## N25 Rosslare Europort Access Road

### ROAD SAFETY AUDIT STAGE 1

November 2021

N25 Rosslare Europort Access Road  
B1 Ballygerry Underbridge  
(Railway Overbridge)  
General Arrangement  
Plan

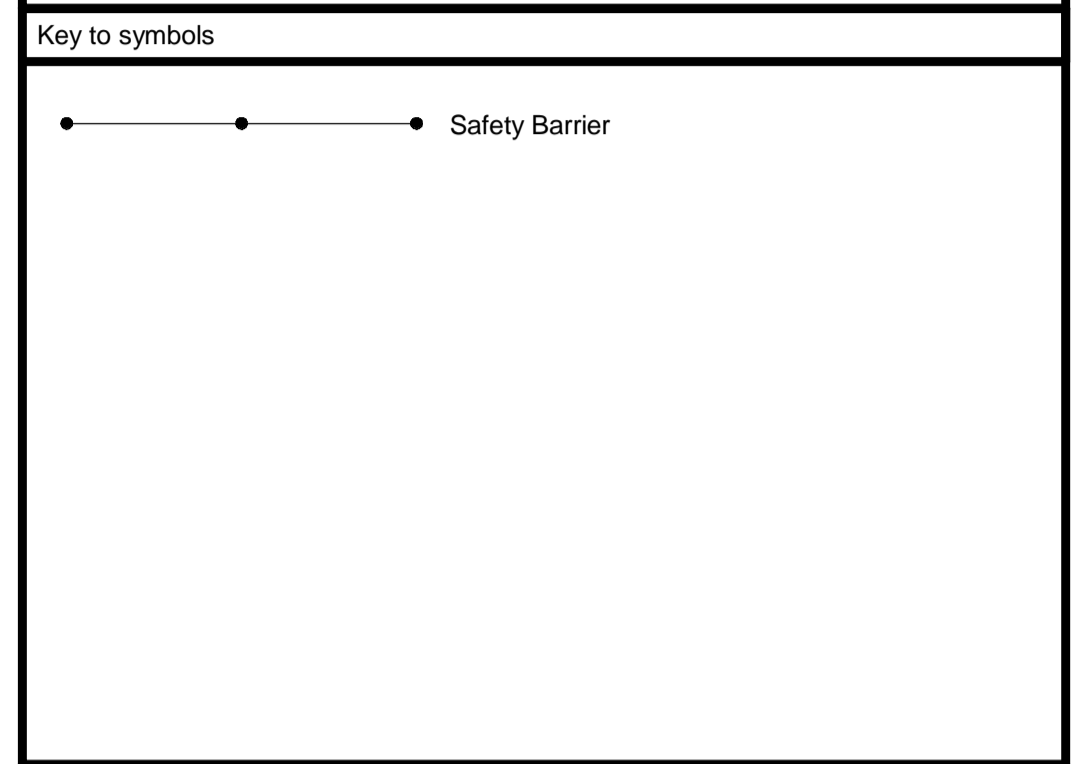
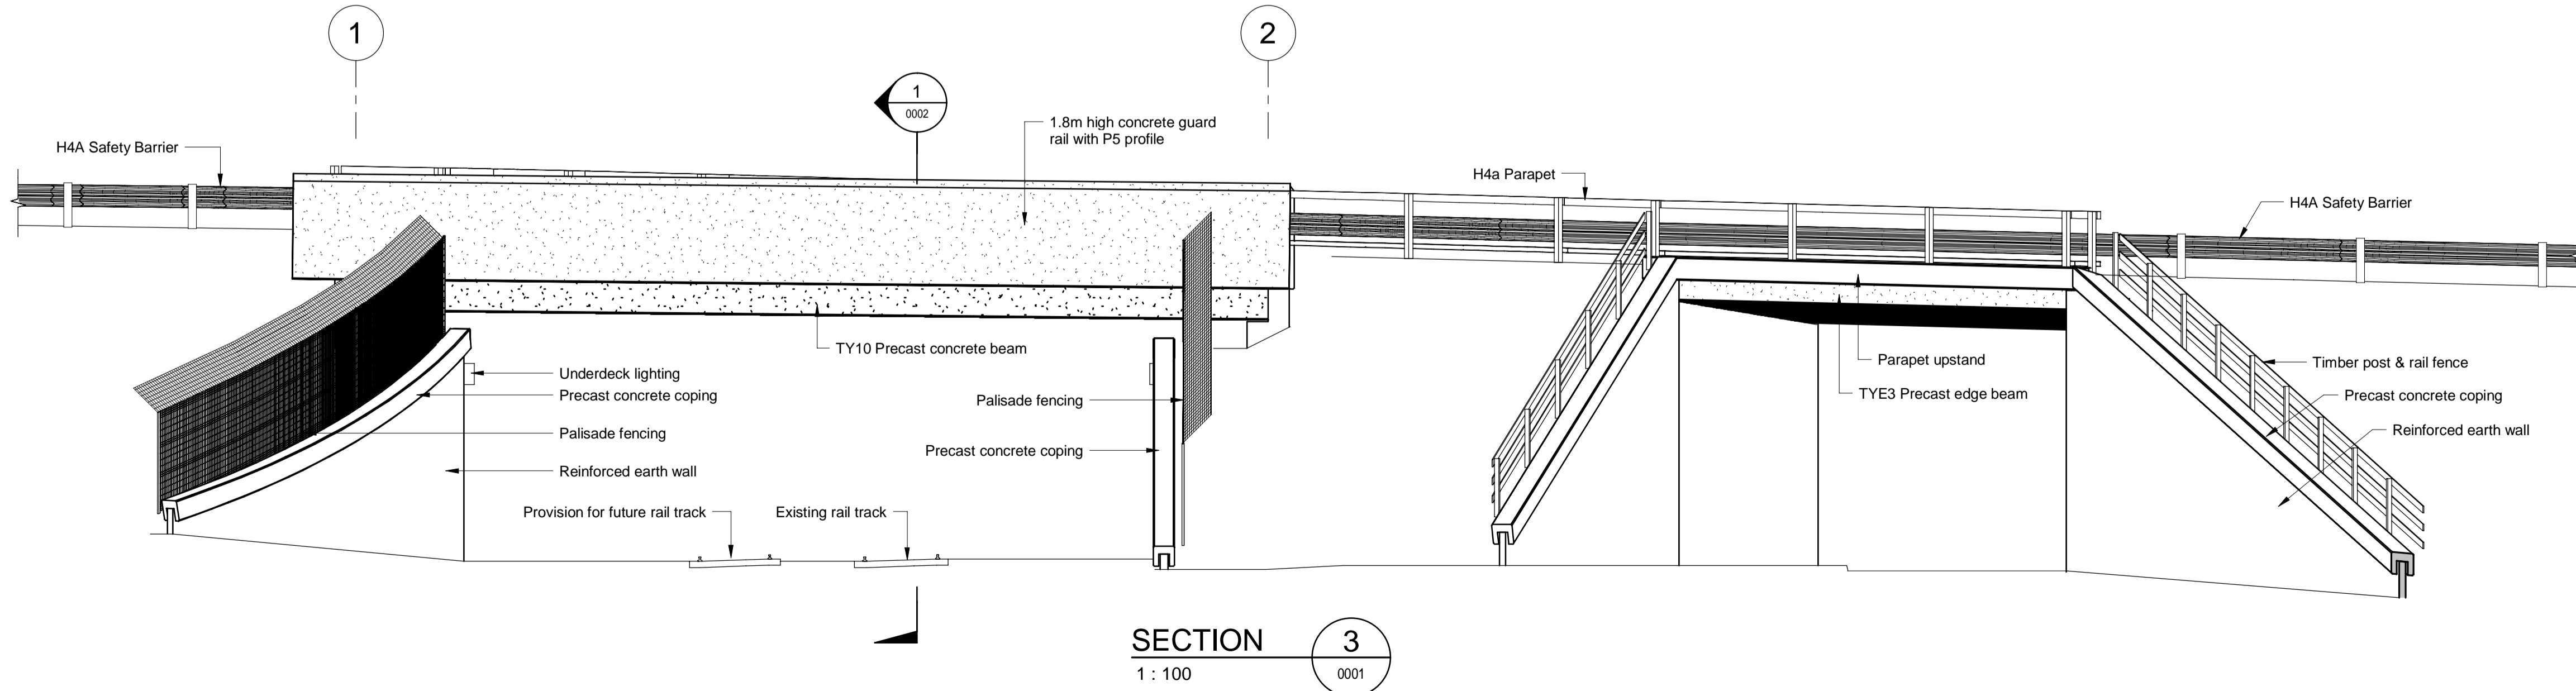
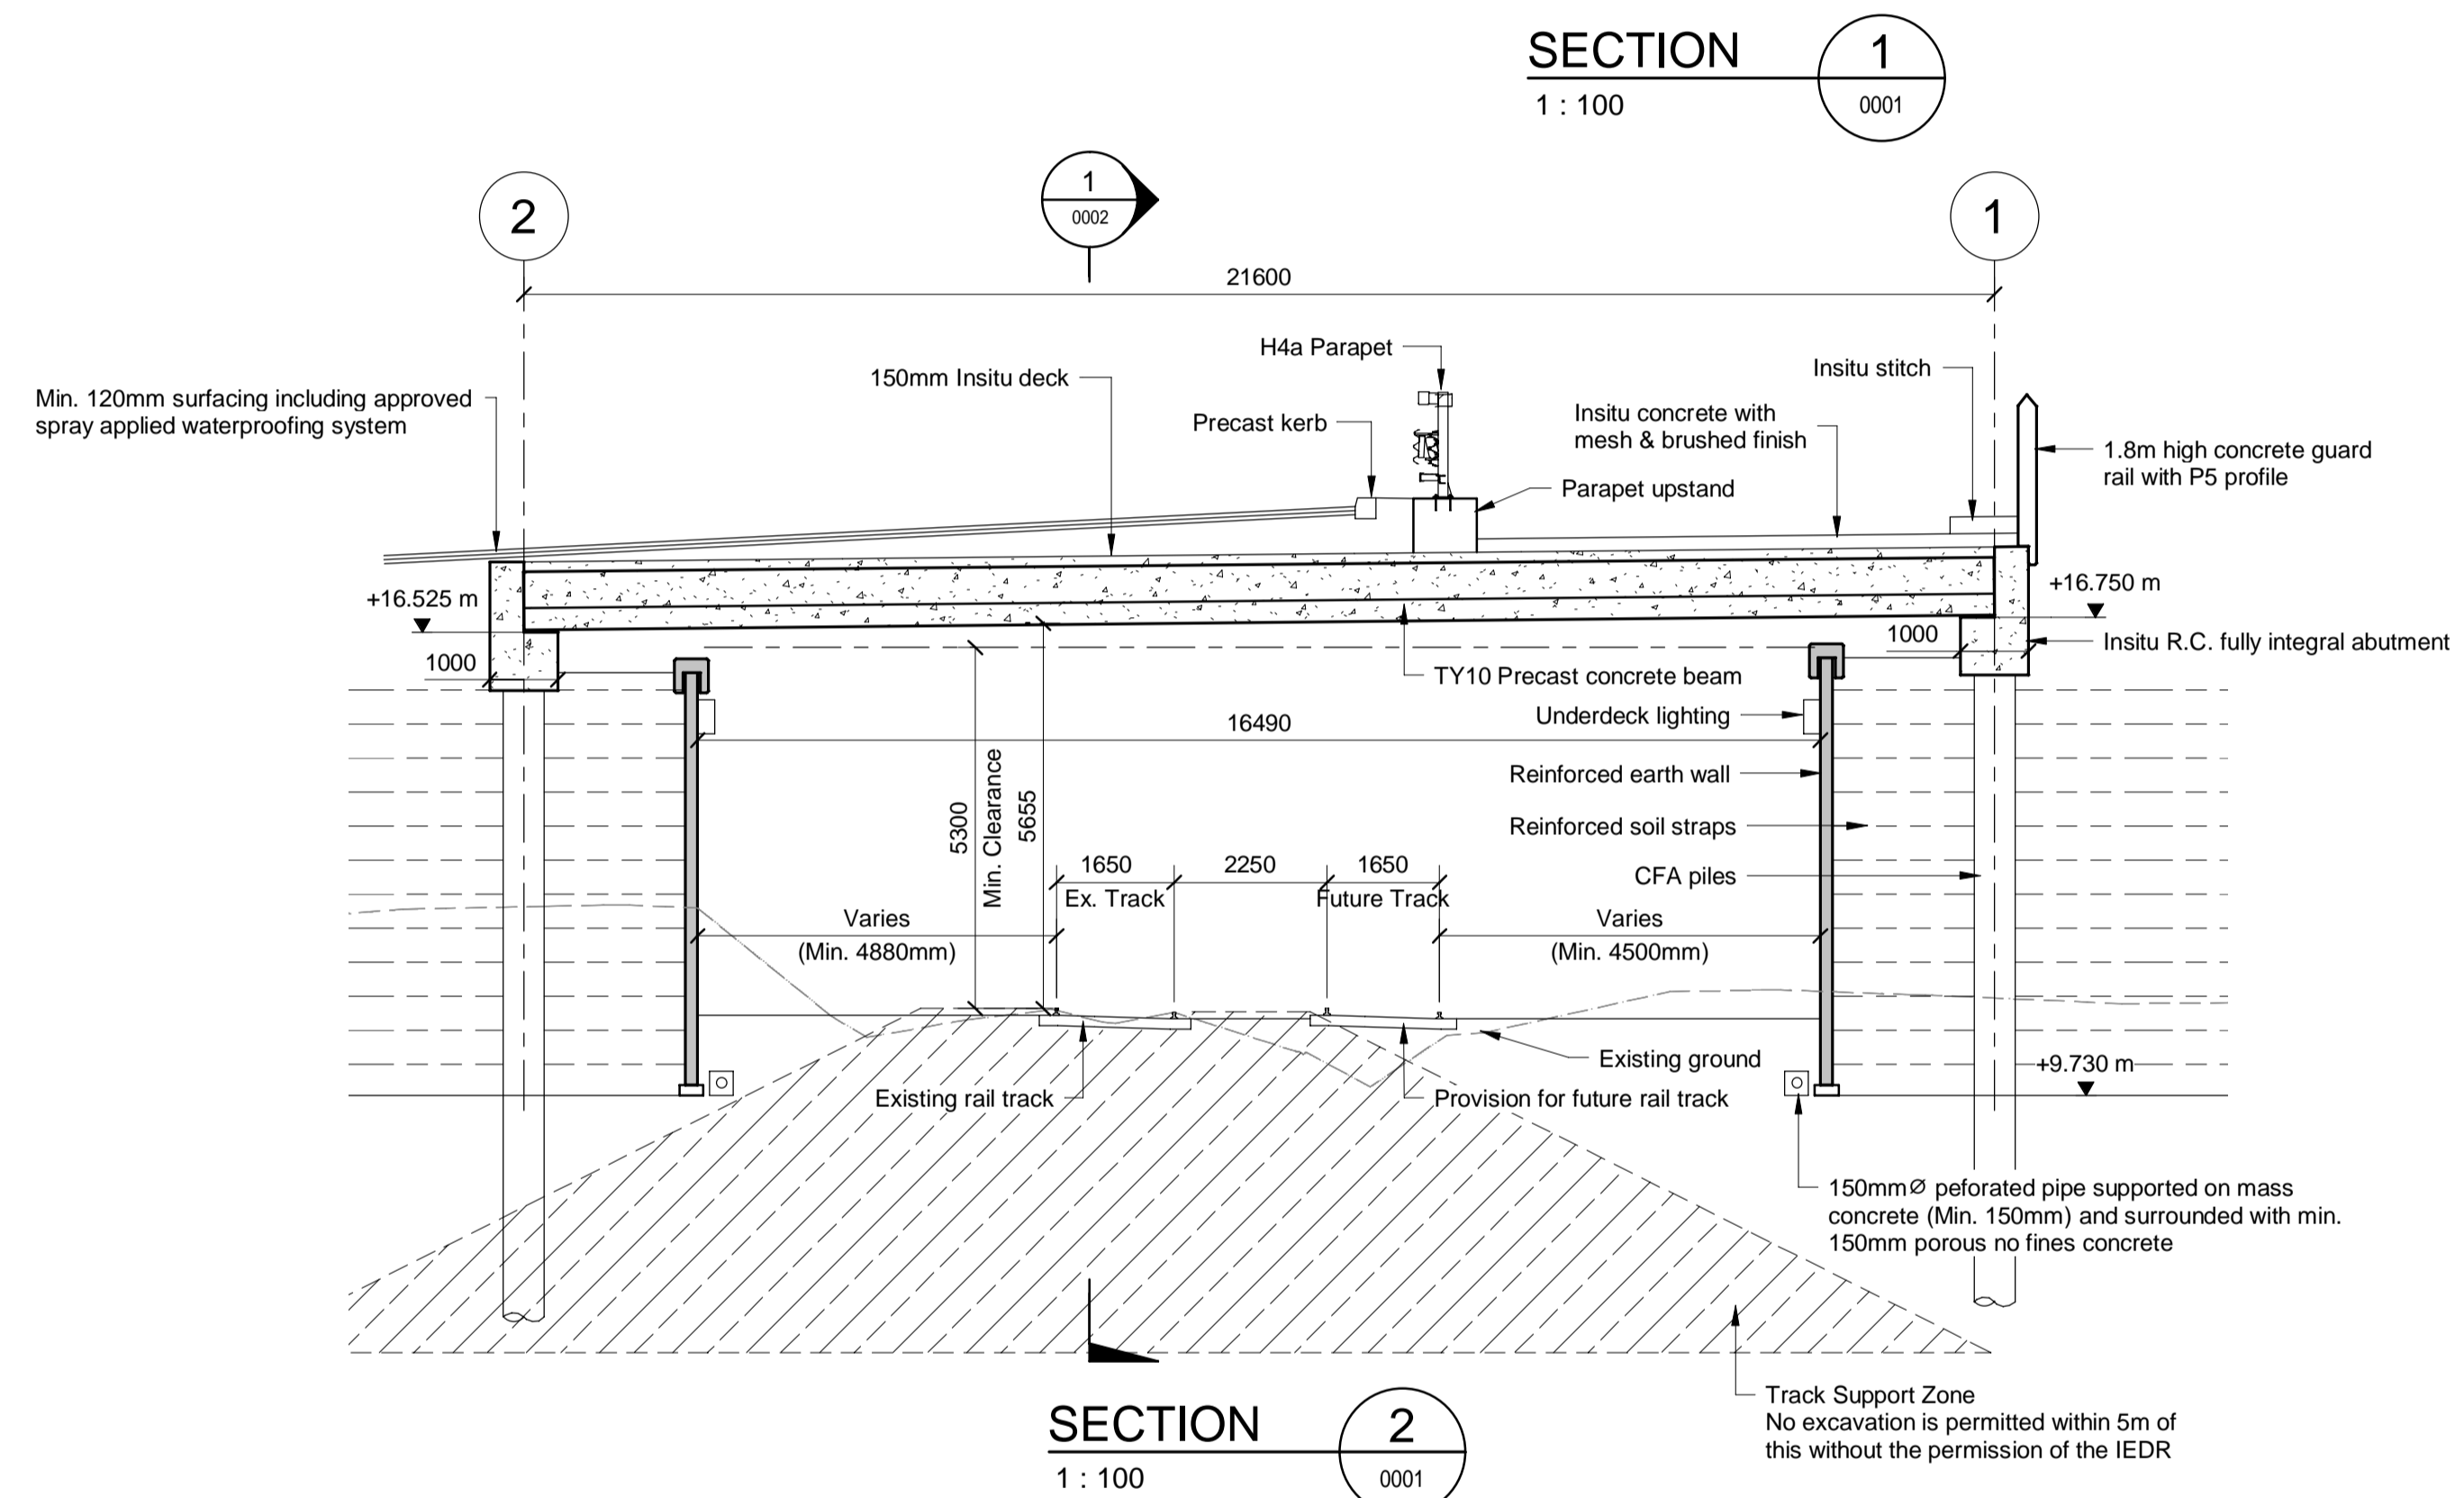
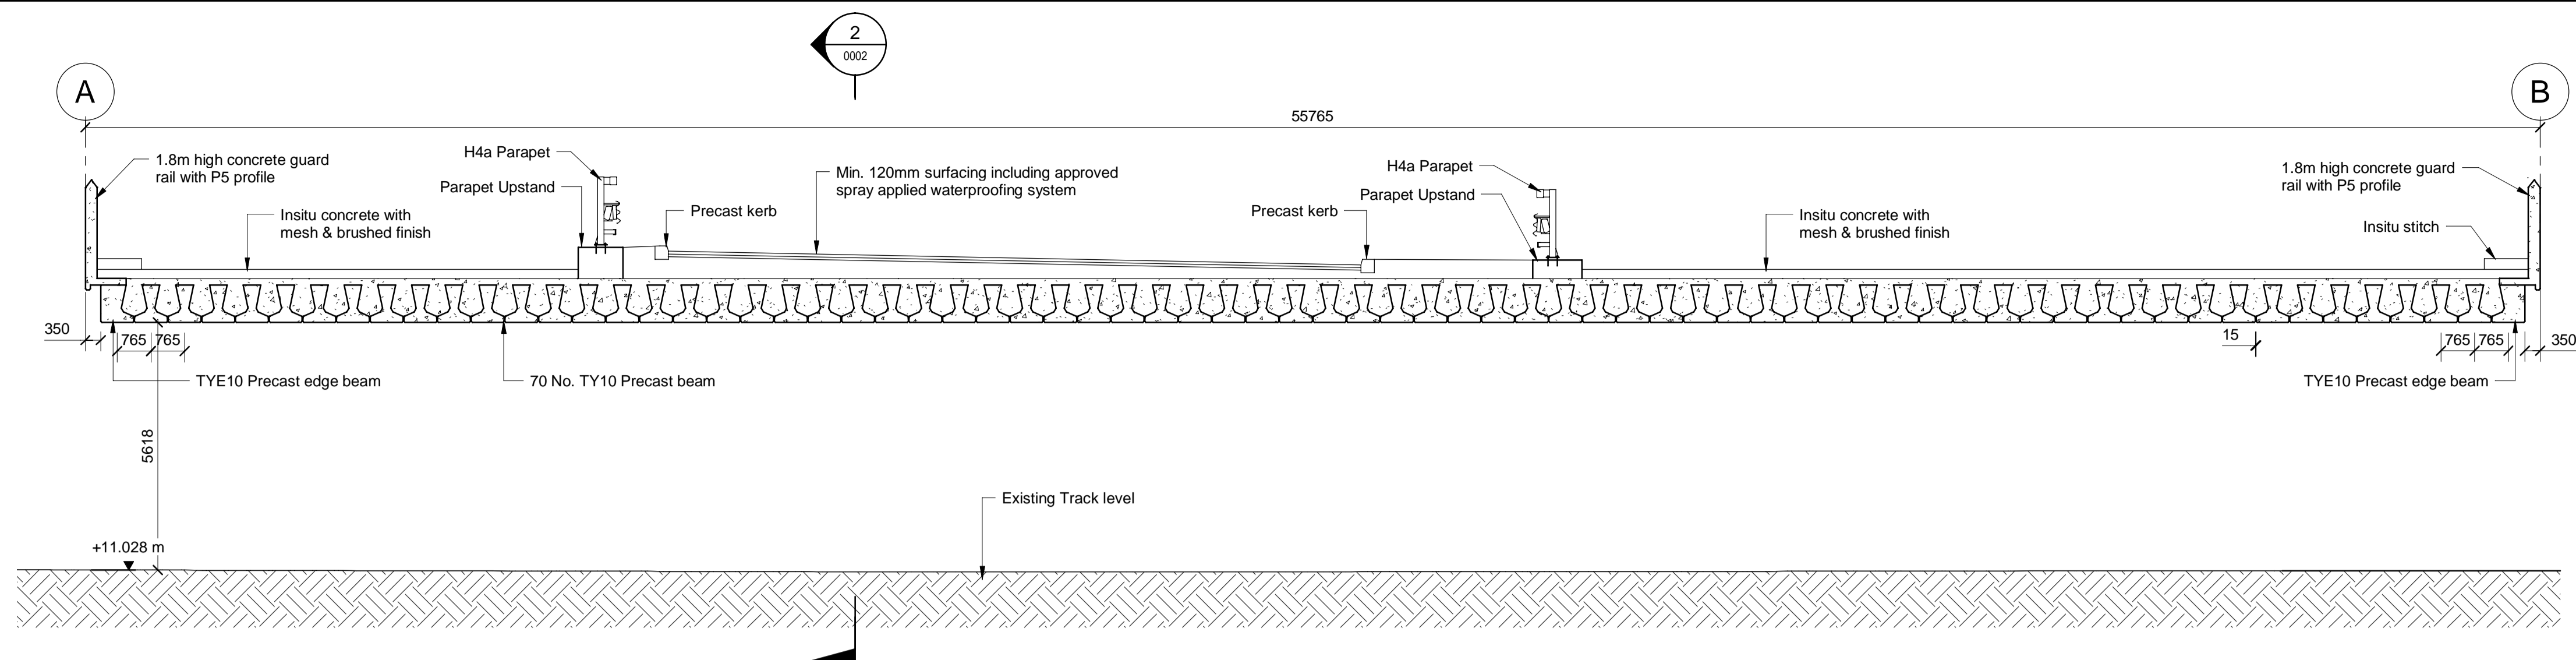
#### 2.6 **Problem: Small layby**

The layby shown adjacent to the railway bridge may not be big enough to contain a larger vehicle without it projecting into the adjacent traffic lane and creating a hazard for other road users.

##### **Recommendation**

Ensure the layby is adequately sized to fully contain the type of vehicle expected to use it.
